Product Change Notification

Change Notification #: 115396 - 00
Change Title: Intel® Ethernet Converged Network Adapter X710-T4, Product Code X710T4G1P5 MM#943101, Intel® Ethernet Converged Network Adapter X710-T4, Product Code X710T4BLK MM#943053, Intel® Ethernet Converged Network Adapter X710-T4, Product Code X710T4 MM# 943052, PCN 115396-00, Product Material, Label, Transport Media, PBA Update and Clamshell Update
Date of Publication: April 07, 2017

Description of Change to the Customer:

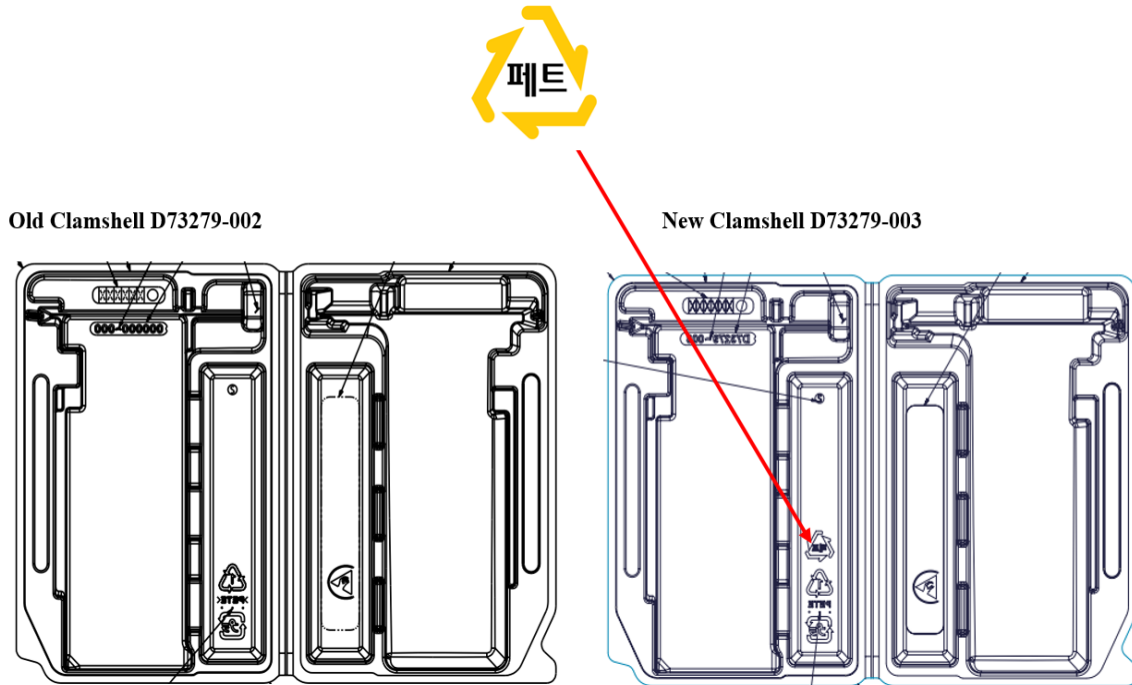
- OEM-Gen - Intel® Eth Converged Nw Adapter X710-T4 Product Code X710T4G1P5 MM#943101
 - Replace PBA J64862-012 with PBA J64862-013.
 - Replace clamshell D73279-002 with D73279-003.
- Retail Single - Intel® Eth Converged Nw Adapter X710-T4 Product Code X710T4 MM# 943052
 - Replace PBA J31241-004 with PBA J31241-005.
 - Replace clamshell D73279-002 with D73279-003.
- Retail Bulk - Intel® Eth Converged Nw Adapter X710-T4 Product Code X710T4BLK MM#943053
 - Replace PBA J31241-004 with PBA J31241-005.
 - Replace clamshell D73279-002 with D73279-003.

- As a result of this change, the PBA (printed board assembly) and TA (top assembly) numbers will roll as noted in the affected products table within this PCN notice. If the PBA/TA numbers are printed on any product or box labels, those will show the PBA/TA dash roll as well.
- Clamshell change for OEM-Gen, Retail Single and Retail Bulk to include Korean recycling logo.

The new PBA improves reliability with the use of all ceramic output caps in the two low voltage supplies, and improves yield with the removal of a via that would occasionally cause issues with manufacturing. There were absolutely no changes to any of the high speed nets; PCI, AFE, etc. No clock rates changed, no edge rates were modified. It is our opinion that this change requires minimal to no validation by our customer.
